Hillside Copper Mine

Mining Lease Proposal Response Document

21 February 2014

Figure 5.9-1: Drainage of the Hillside Project Area and Pre-development Sub-catchments

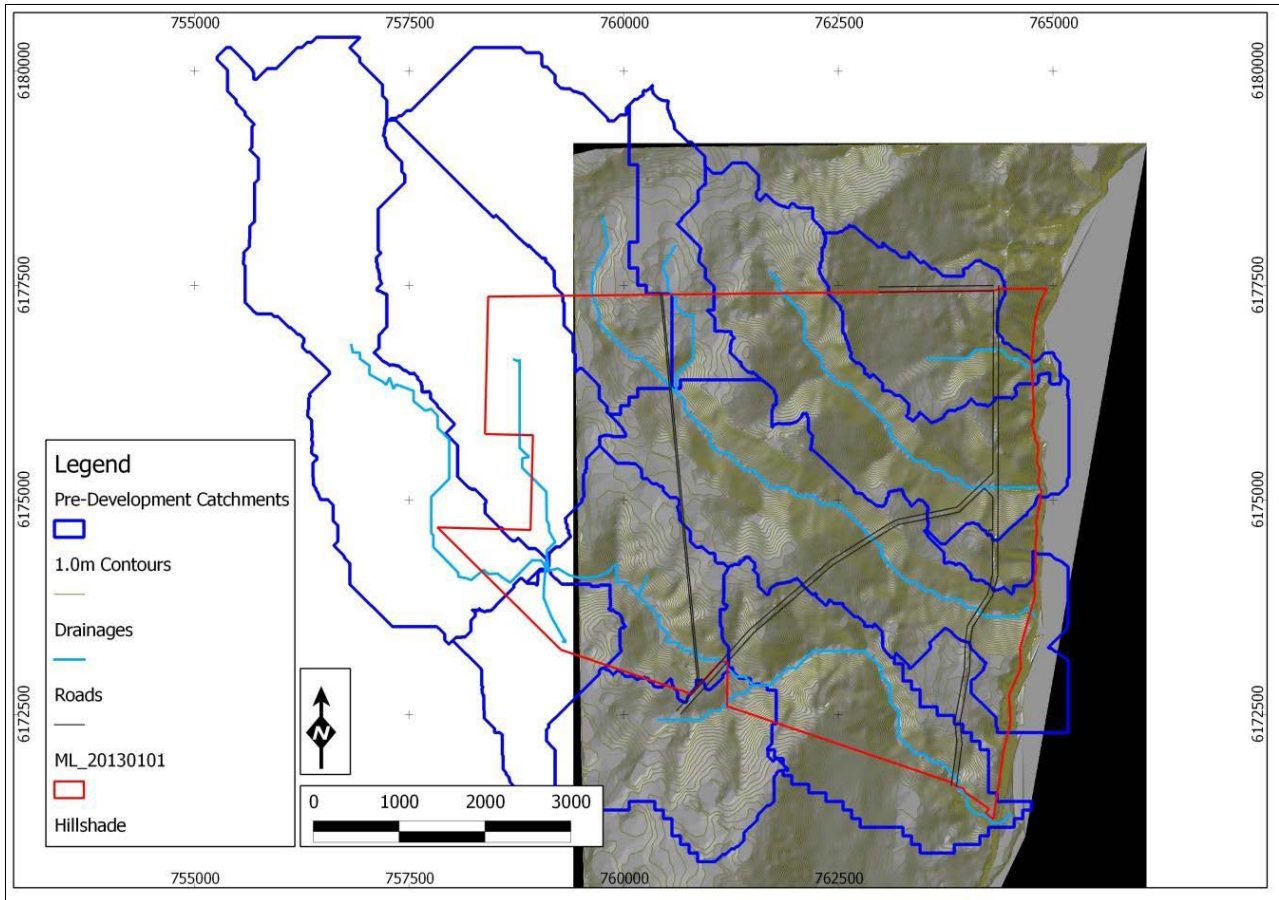
Section 5.9 - Figure 5.9-1 is missing. Provide Figure 5.9-1

Figure 5.9-1 which was missing in the MLP has been provided below.

Figure 20: Potentiometric surface map - basement aquifer March 2013

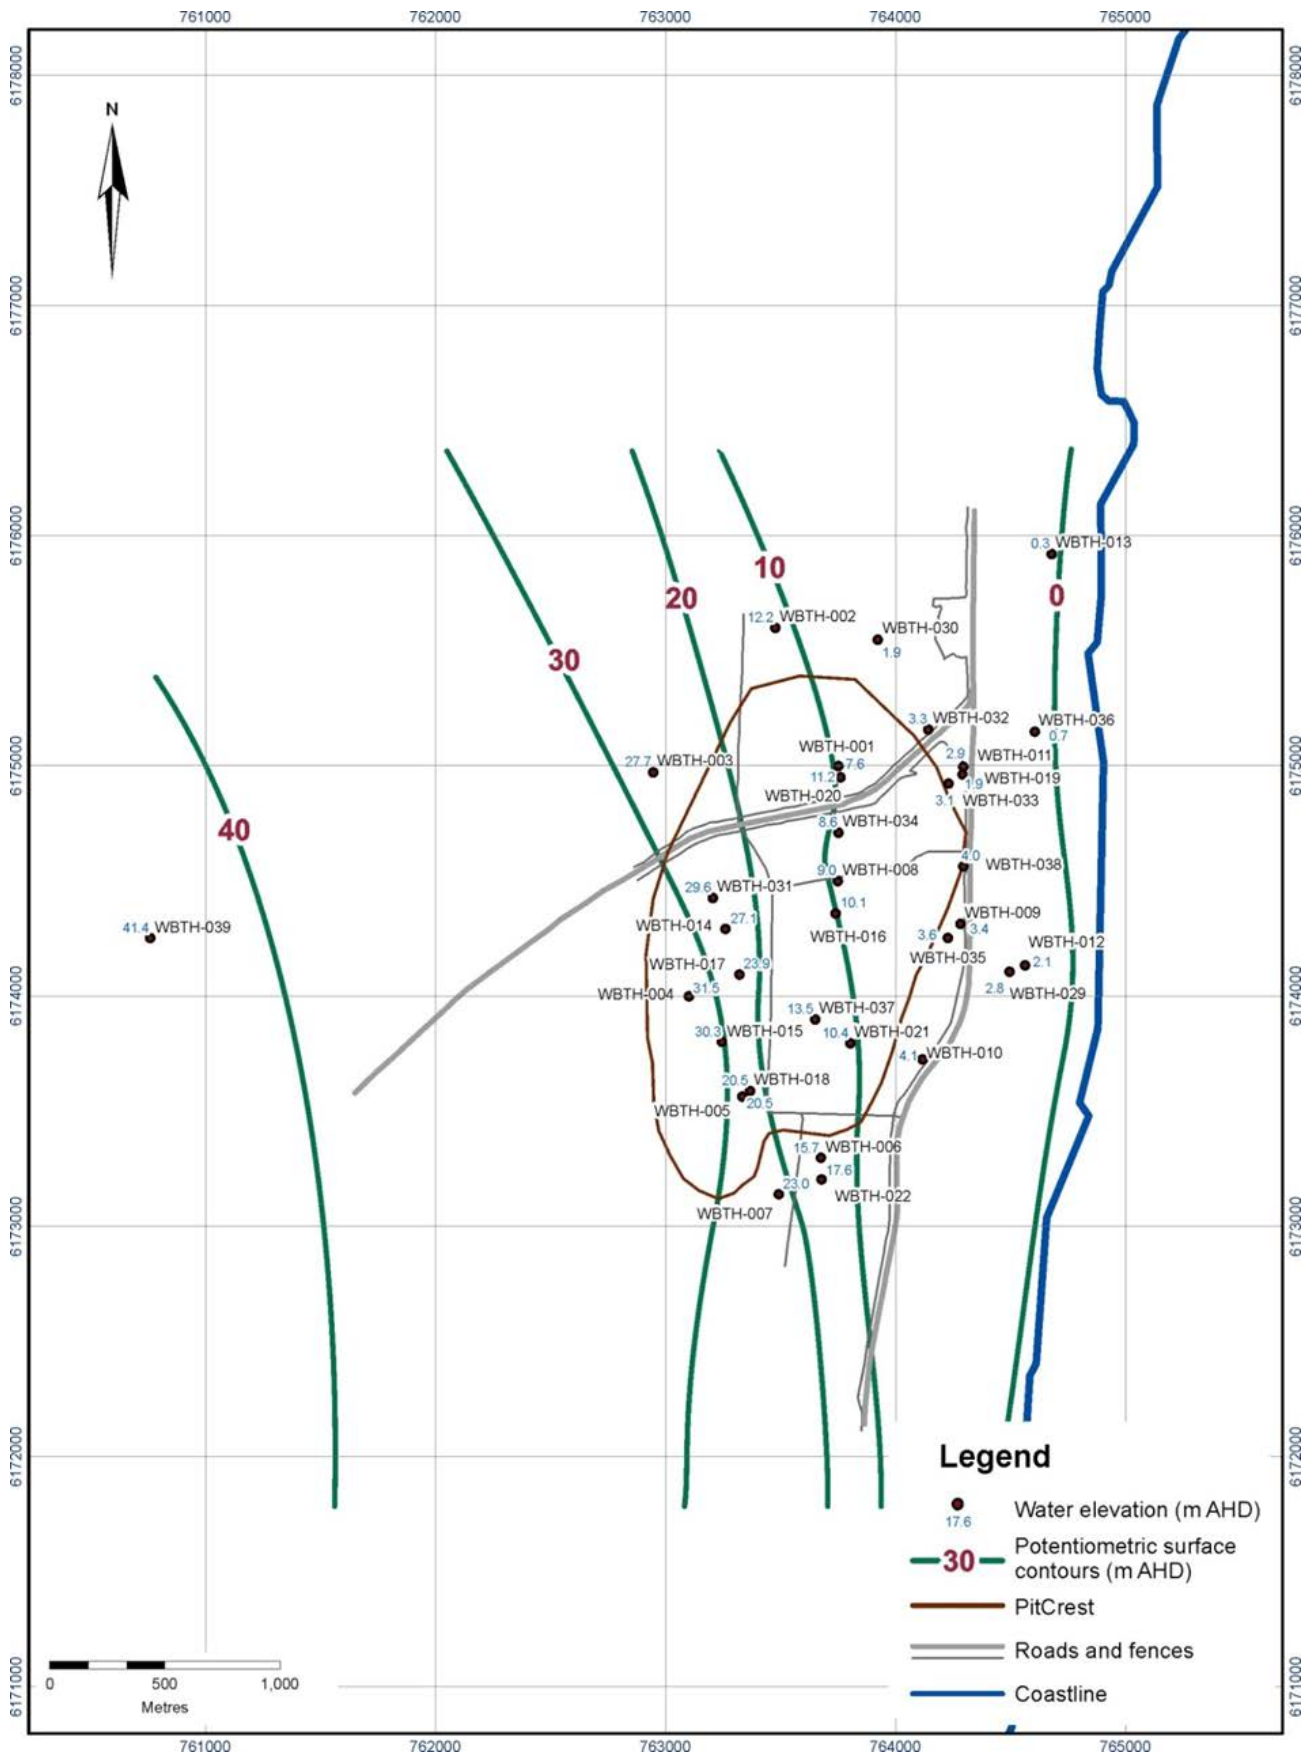
Figure 5.10-7: Data points for standing water levels do not all correspond with the contour value indicated on the potentiometric surface e.g. WBTH-31 plots within the 20-25 m contour interval, yet reports at RSWL of 30.8 mAHD.

Contour values indicated on the potentiometric surface have been amended. Refer to Figure 20 of **Response_58. Water.**

Figure 21: Cross Section at 6173500 m N

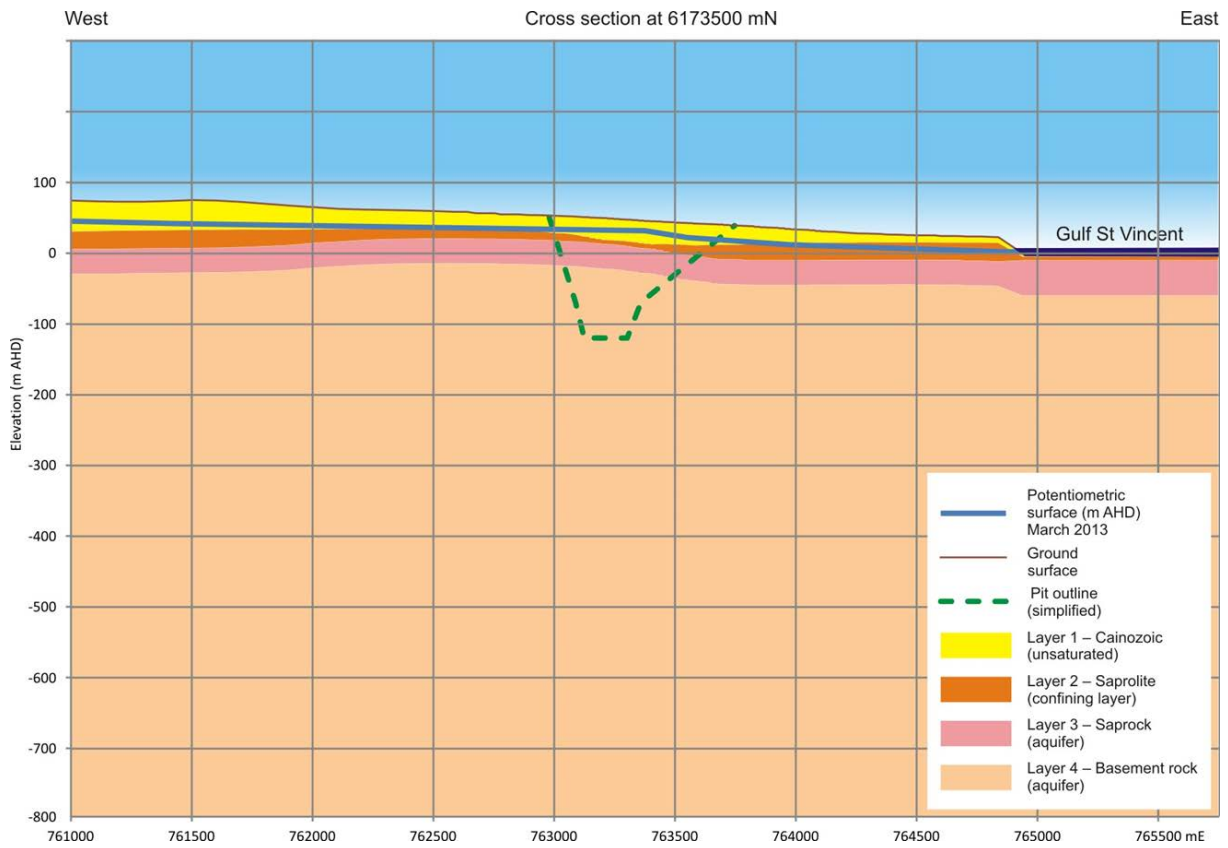
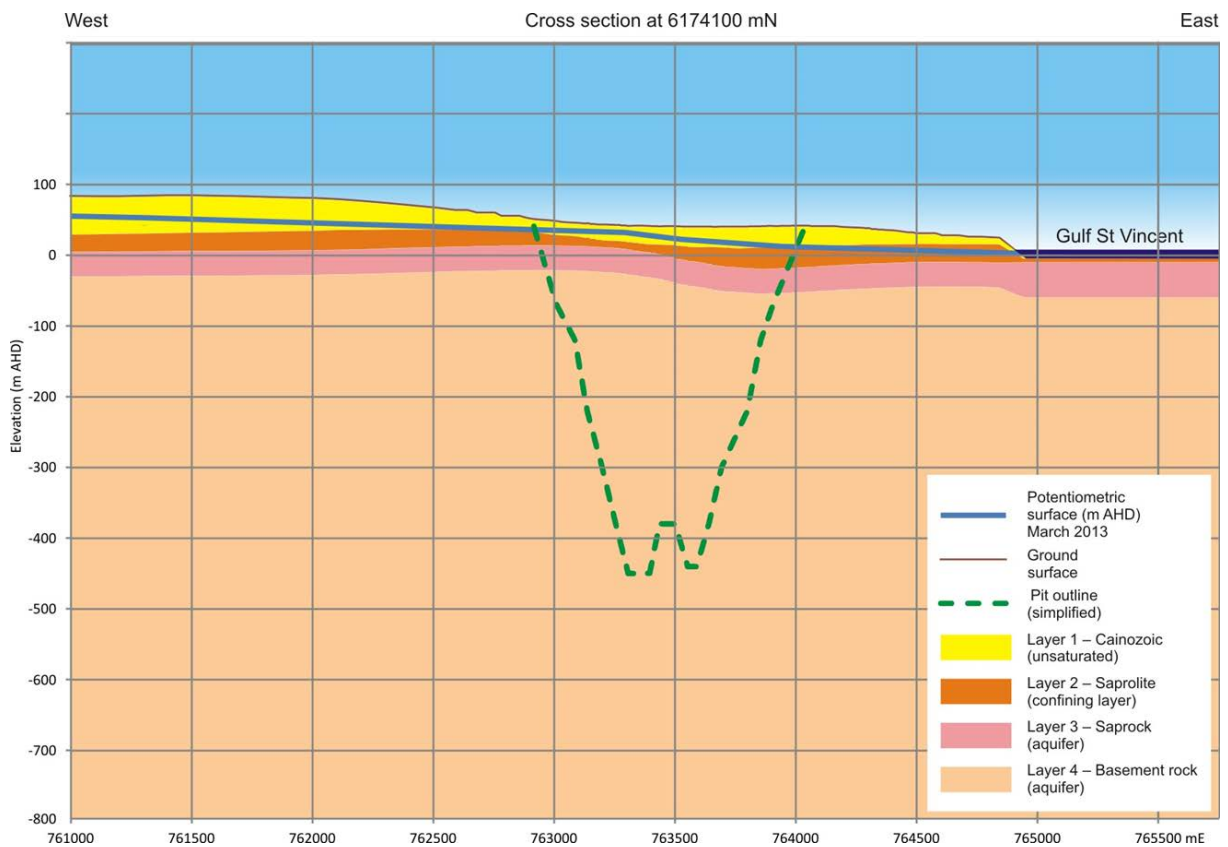
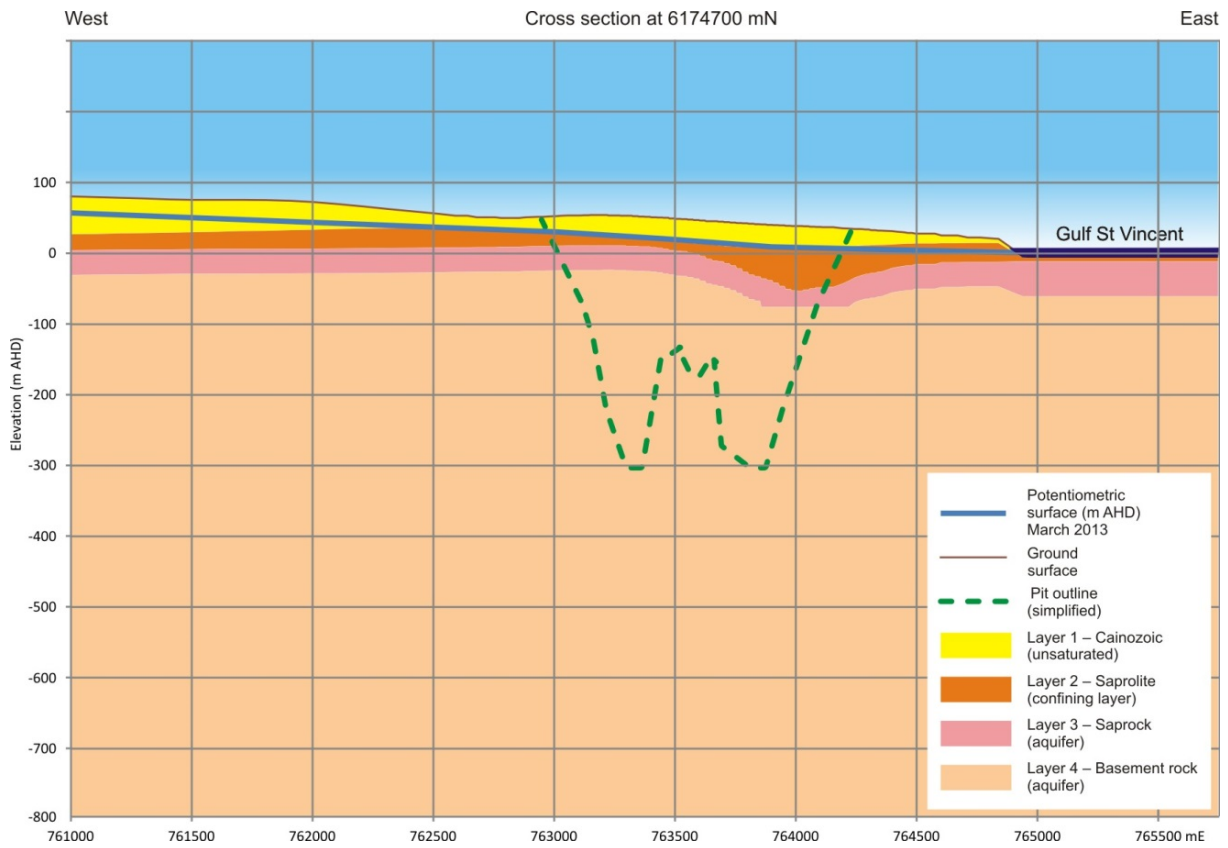
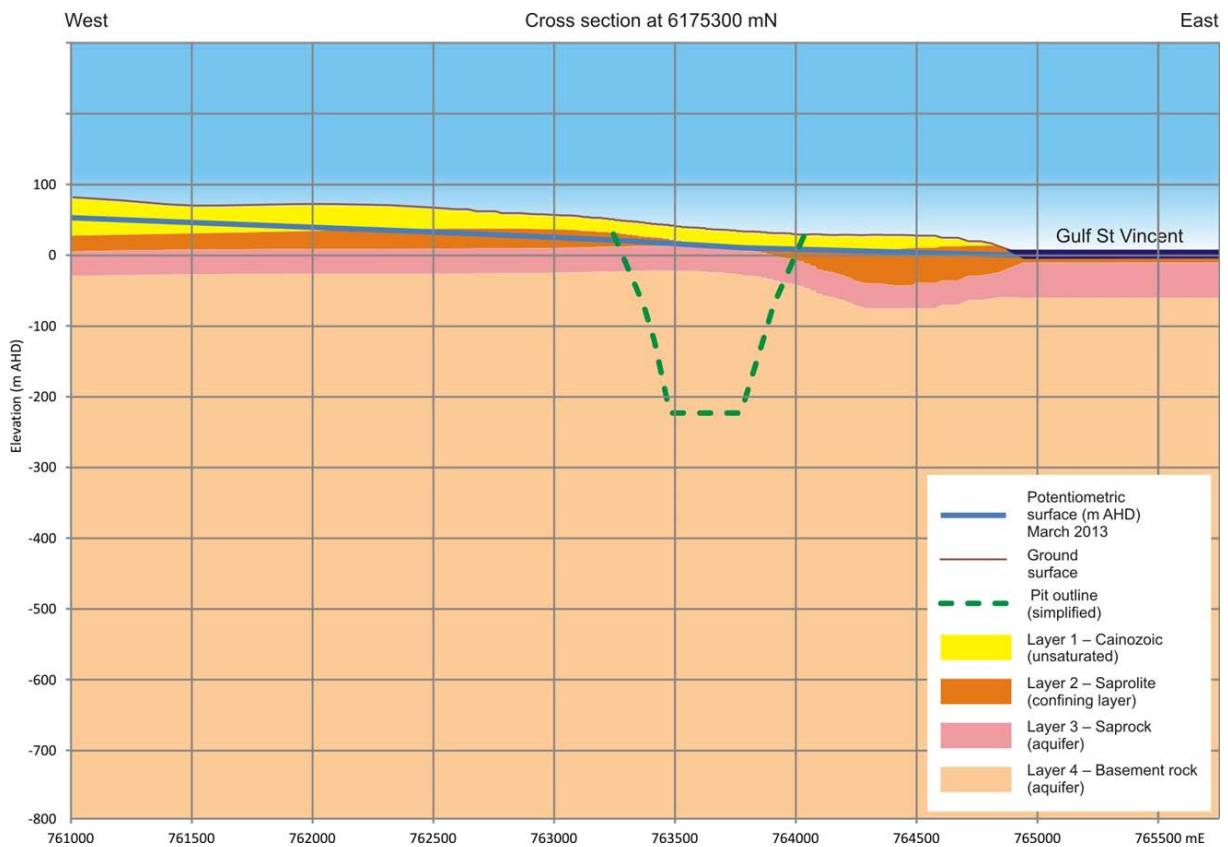
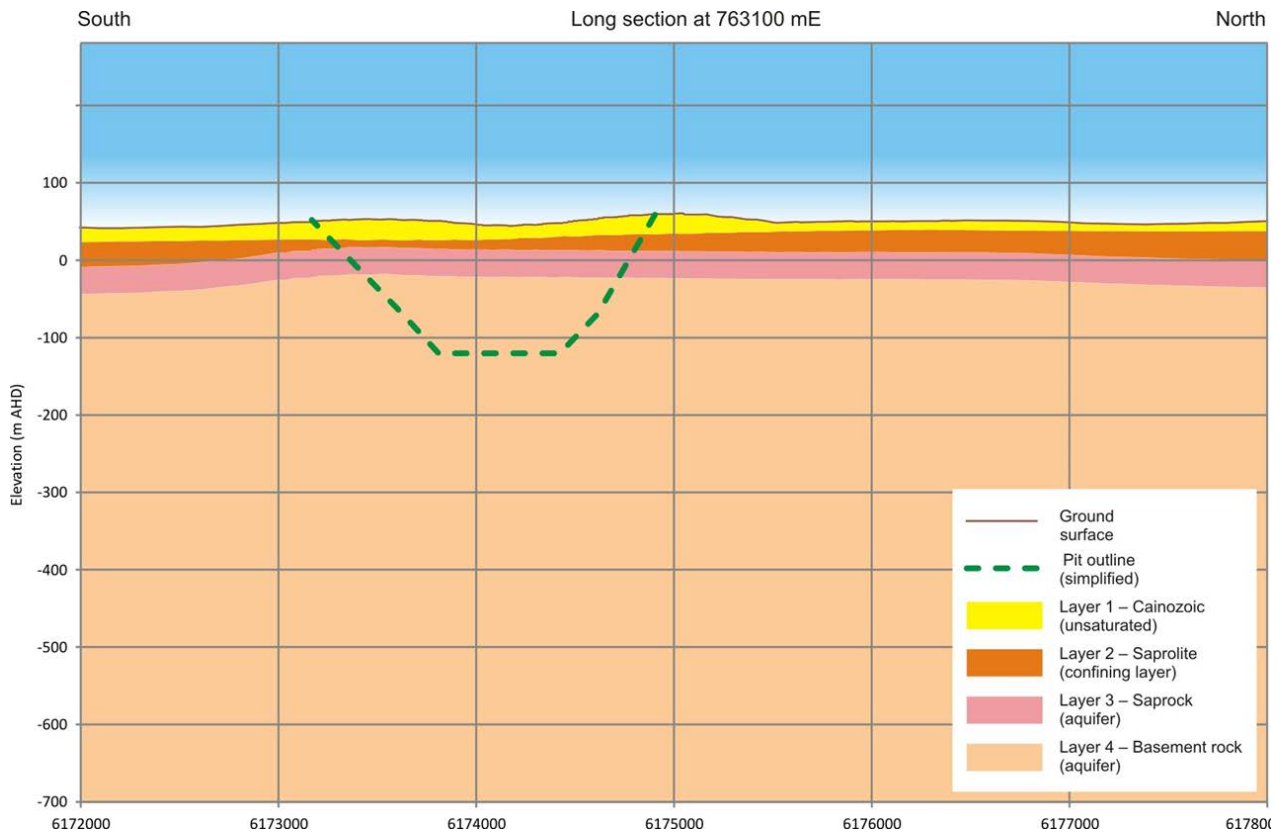
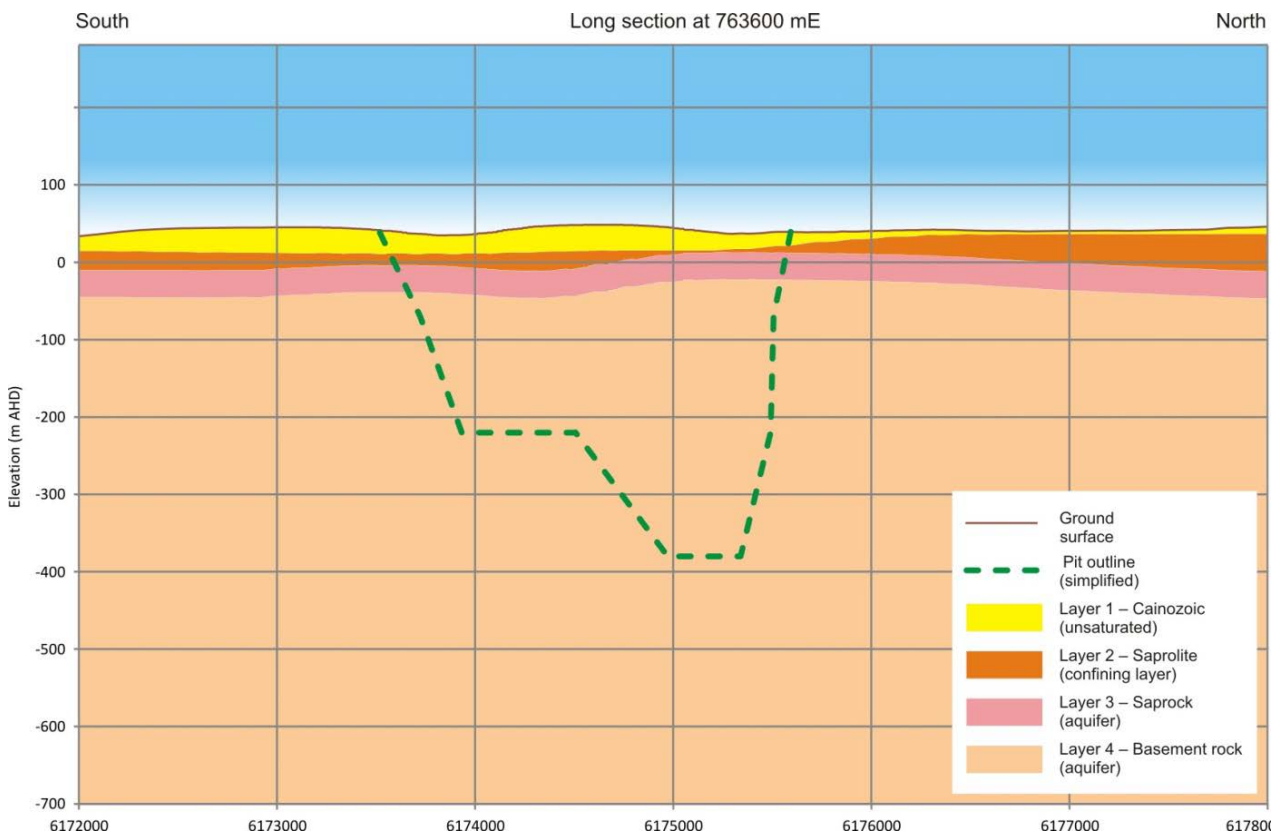
- **What is the approximate thickness of the single confined to unconfined aquifer?**
- **How does the aquifer relate to the geological cross section schematic (Figure 5.10.1)**

Cross and long sections from the groundwater model are presented below in Figures; Figure 21 to Figure 27. A section location plan is also presented in Figure 28. A potentiometric surface map for the basement rock aquifer is presented in Section 9 of **Appendix 7**. Potentiometric surface traces for the basement rock aquifer are also shown in the cross sections. Recharge mechanisms are stated in Sections 7, 12 and 13 of **Appendix 7**, i.e. recharge is by lateral throughflow from the west. The discharge mechanism is stated in Section 7 of **Appendix 7** - 'Groundwater flow is from west to east, i.e. from the Hillside Deposit to Gulf St Vincent', this is also indicated by the potentiometric surface contours.

Figure 33: Groundwater model - Kh values in Layer 3

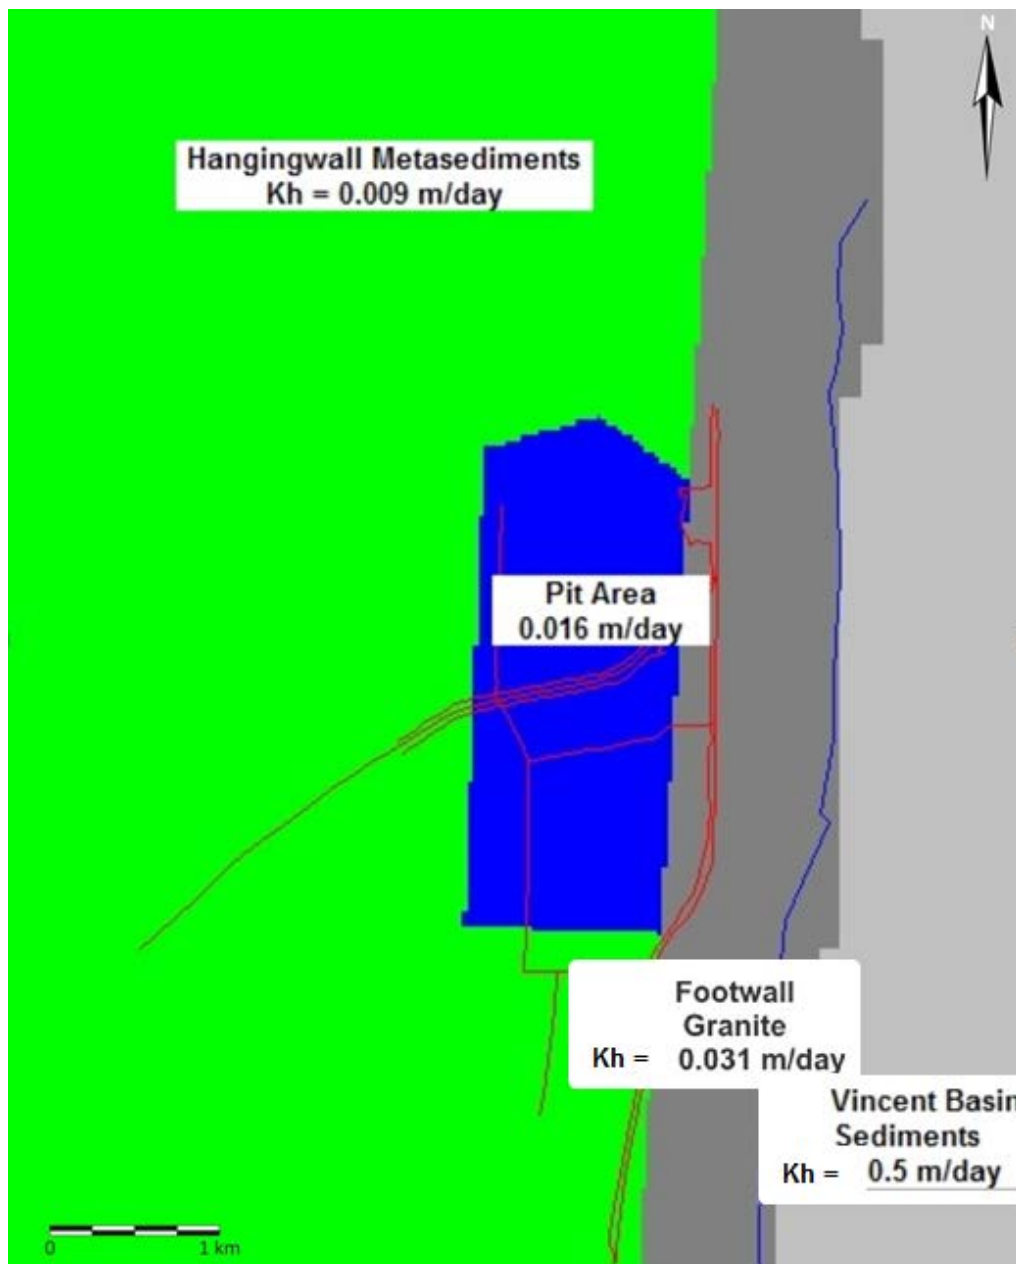
Figure 5-7: The Kh value for the footwall granite is missing.

The Kh value for the footwall granite is 0.031. The figure has been updated, see Figure 33 directly below.
